# City of Ukiah, CA

## Design Review Board

### MINUTES

36 **6A. Chipotle's Mexican Grill Restaurant 596 East Perkins Street, (File No.: 842)** Review  
37 and recommendation to Planning Commission on a Site Development Permit for  
38 construction of a 2,000 square foot Chipotle Mexican Grill restaurant on the vacant parcel  
39 located in the Downtown Zoning District at the northwest corner of East Perkins Street  
40 and Orchard Avenue. On-site parking and landscaping are also proposed, as is outdoor  
41 dining along both street frontages at 596 East Perkins Street, APN 002-200-38.

Alan Nicholson  
proposed modifications

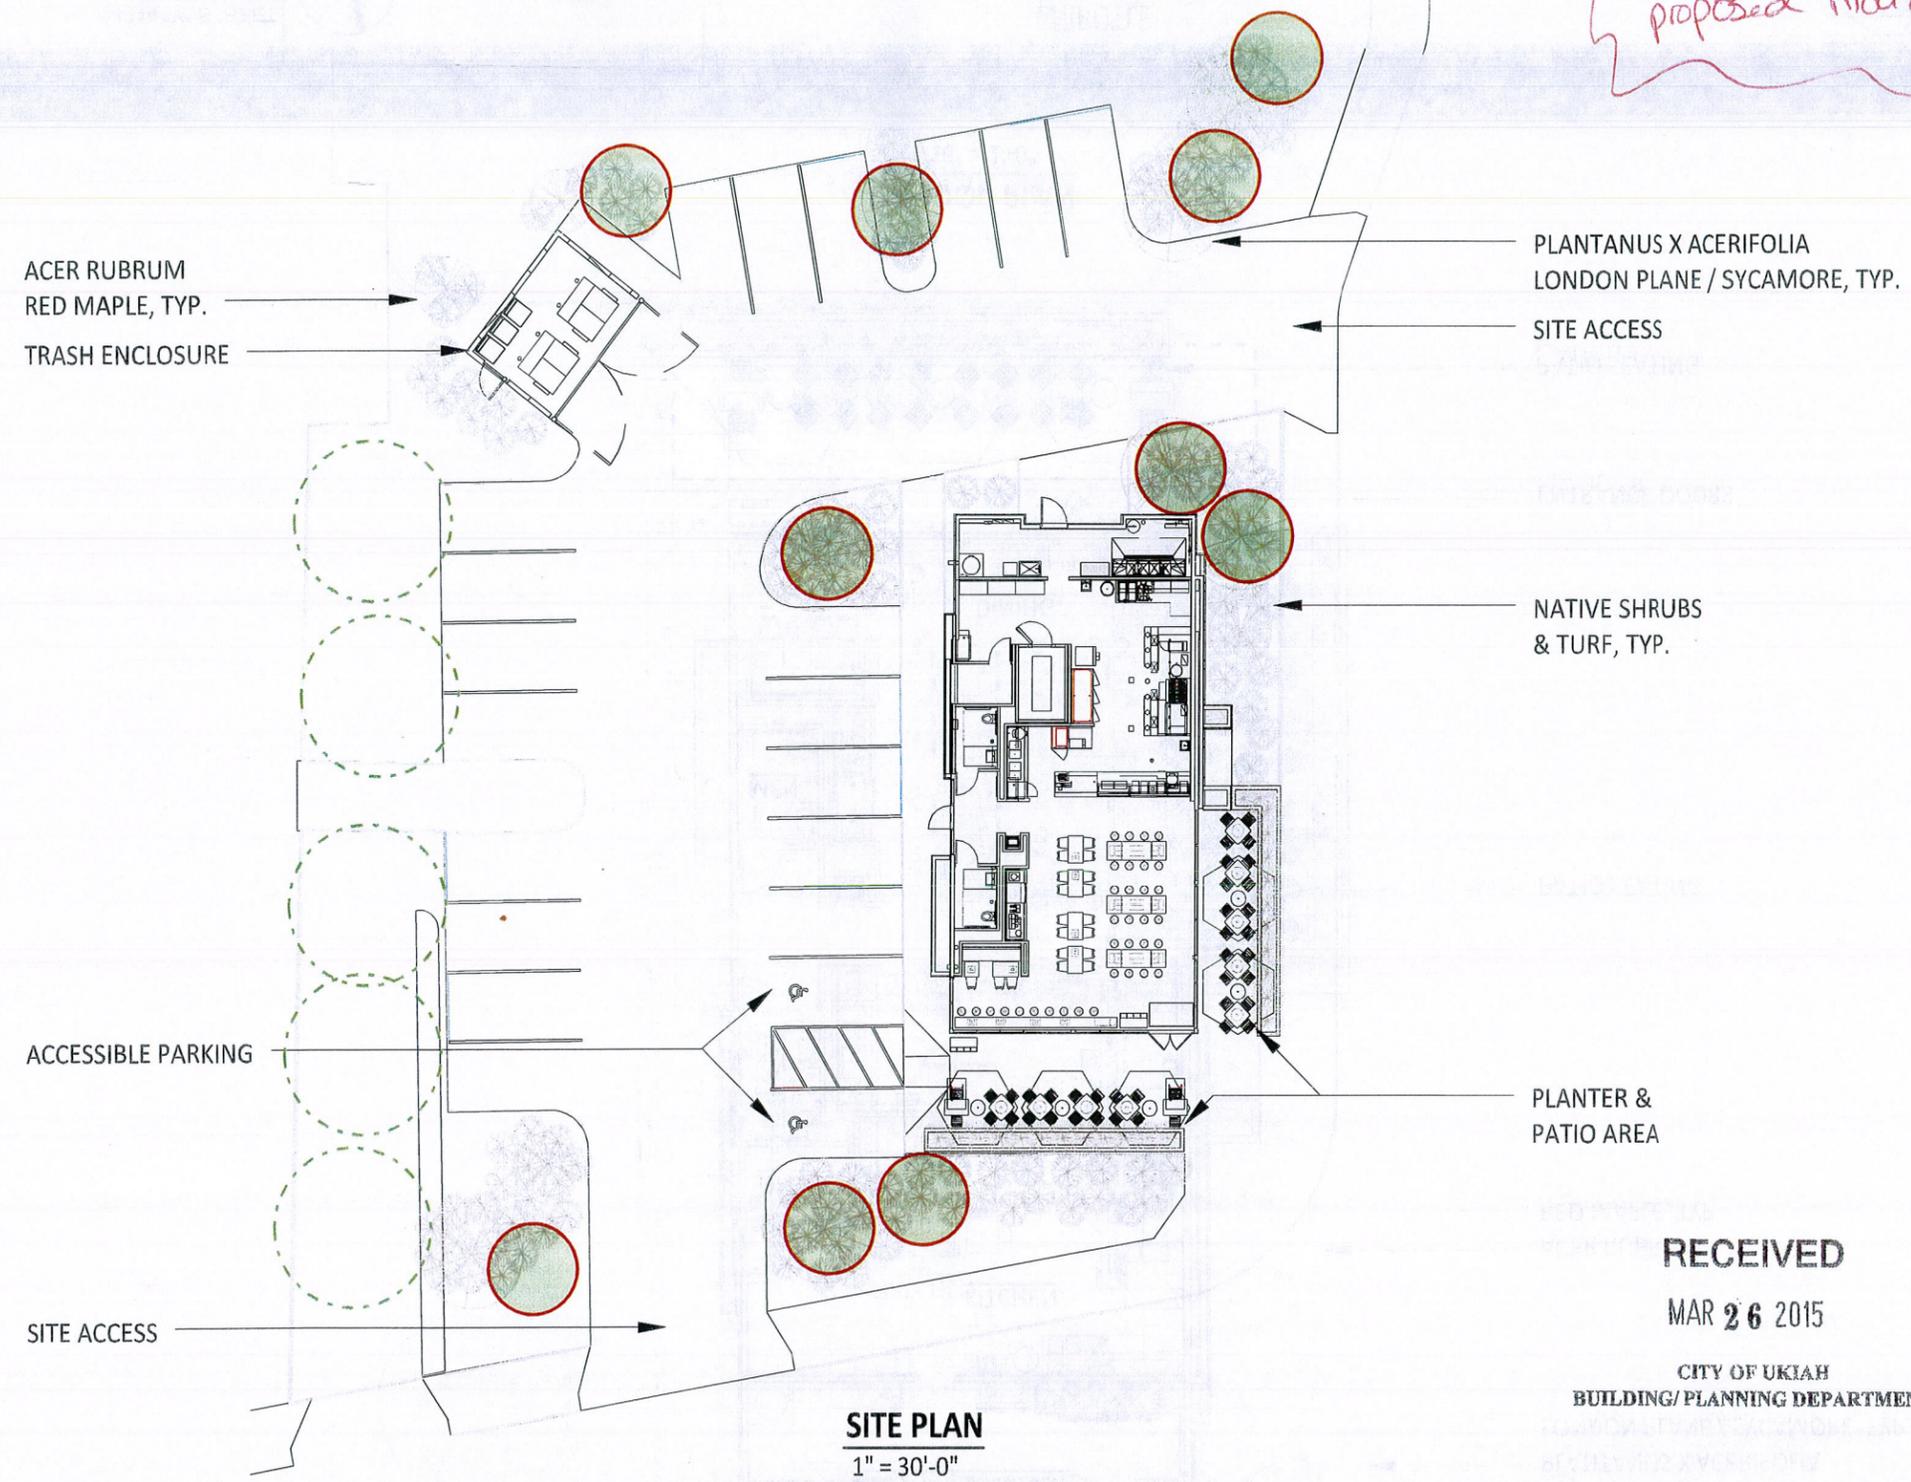
- 49 • Questioned access to the rest of the shopping center. If a person wants to drive to the  
50 restaurant, it would be difficult to get onto the freeway without some maneuvering and  
51 forethought. Is there a way to get access to the parking lot?
- 52 • Supports having well-defined pedestrian access from the shopping center.
- 53 • Related to having a streetscape plan in place at some point referred to his proposed  
54 landscaping modifications that are incorporated into the minutes as attachment 1.

- Related to the proposed landscape plan was not clear what are trees and what are shrubs. Supports having more substantial trees and is of the opinion this approach would provide for a more pedestrian friendly environment as well as soften the corner area while leaving it open enough for the advertising of the restaurant.

- Referred to sheet 2 of his proposed project modification plans related to the building as 'a user' where his preference would be to pull the awning outward so it covers the outdoor dining area, which would provide for a shelter but leave an opening between the building and the outdoor dining area with the hope it would not compromise the mass/size, scale and proportion of the building. Supports the property owner and architect consider this design amenity. Important to get the design concept because of the potential effect this building will have in the neighborhood and with it being located at an intersection on a primary gateway. Is of the opinion allowing for nice pedestrian entry from the shopping center area and having a dining area that is sheltered creates more of a 'sense of place.'

**SITE PLAN**  
1" = 30'-0"

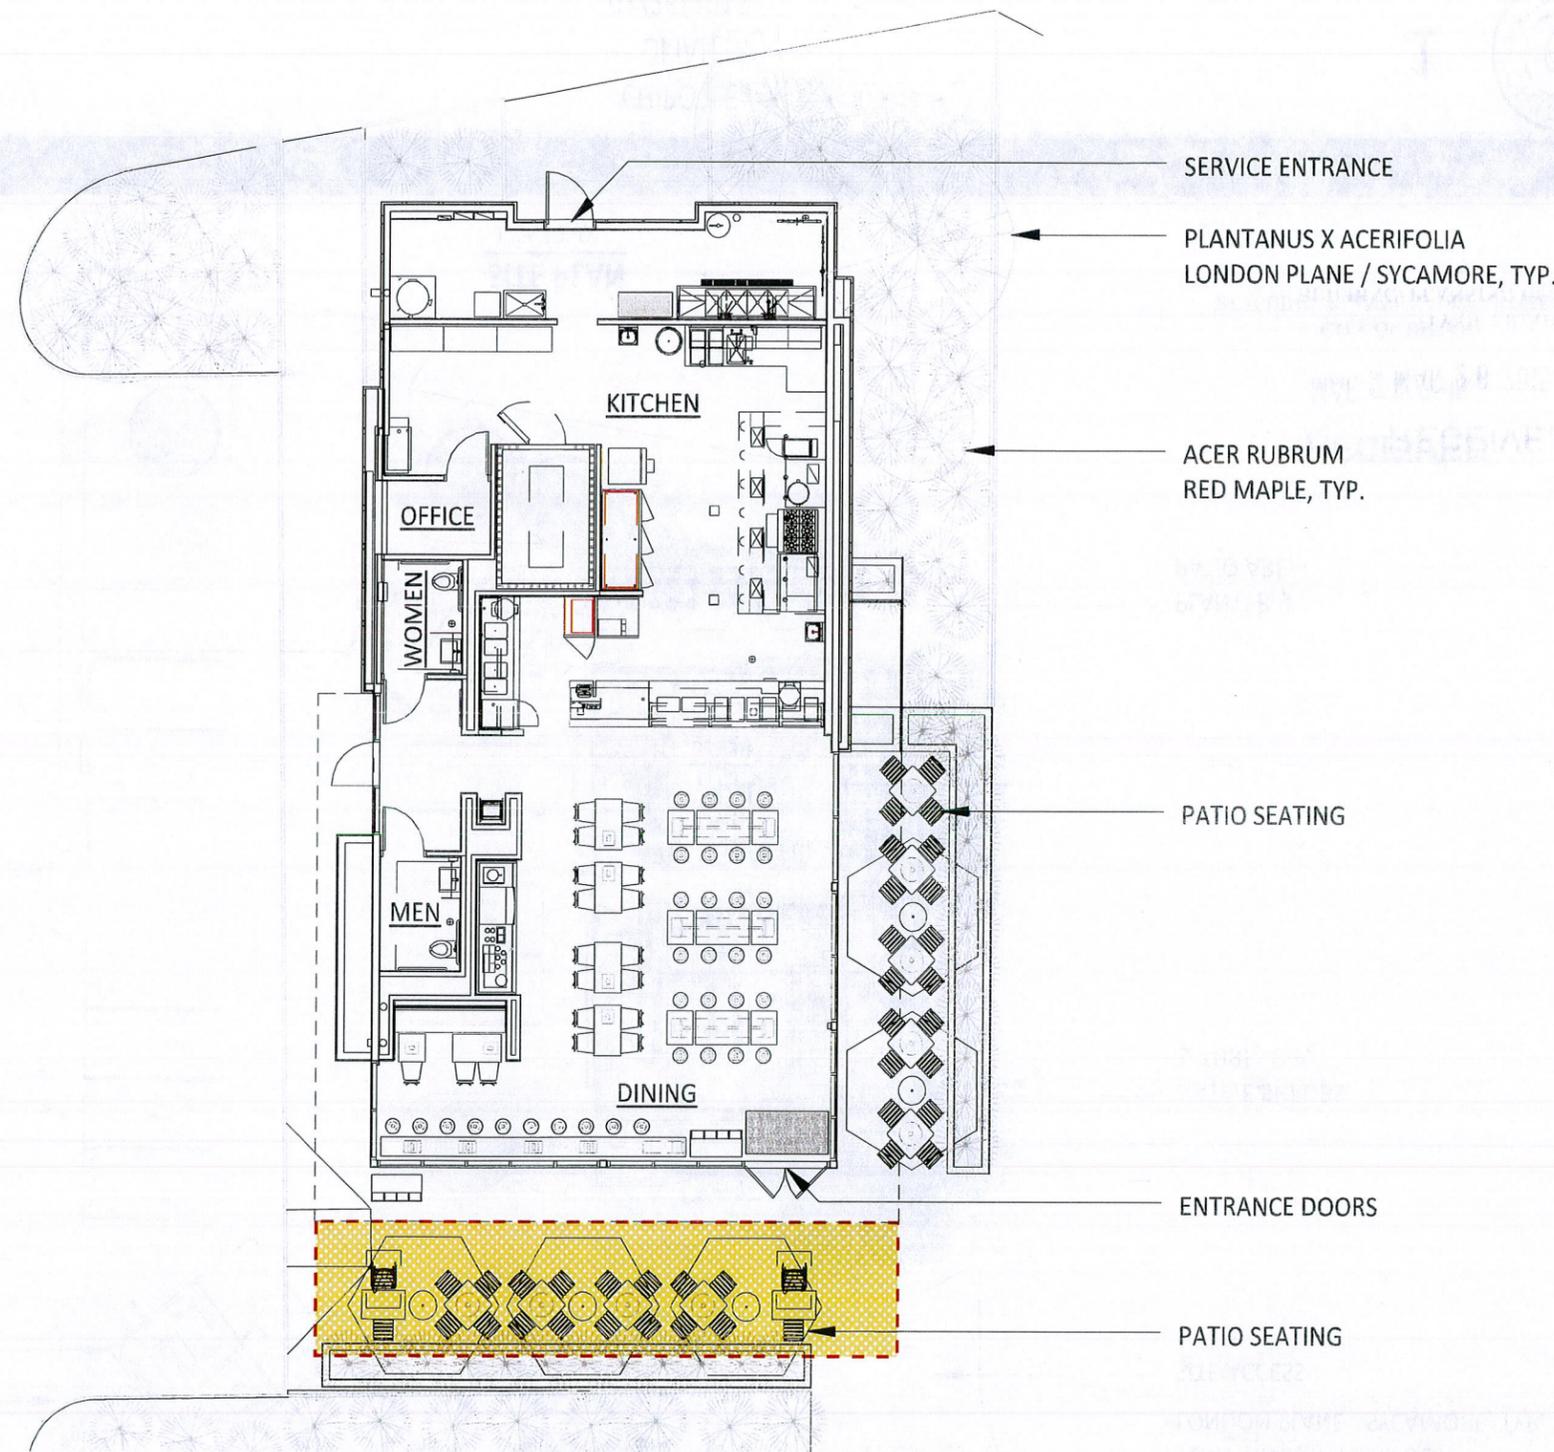
- Two project components that require consideration are site circulation and the fact that the Orchard Avenue property line is askew and is not a complete rectangle. Consideration must also be given to the 10-foot public right-of-way in front on Perkins Street and this is the reason no landscaping and/or trees are shown on the site plans in this area.

- 3 • Referred to the revised site plans dated March 26, 2015 and the *draft* Perkins Gateway  
4 Streetscape Study rendering incorporated in the minutes as attachment 2 and talked  
5 about the City easement/public right-of-way area on Perkins Street in connection with the  
6 planter area that fronts the property.  
7
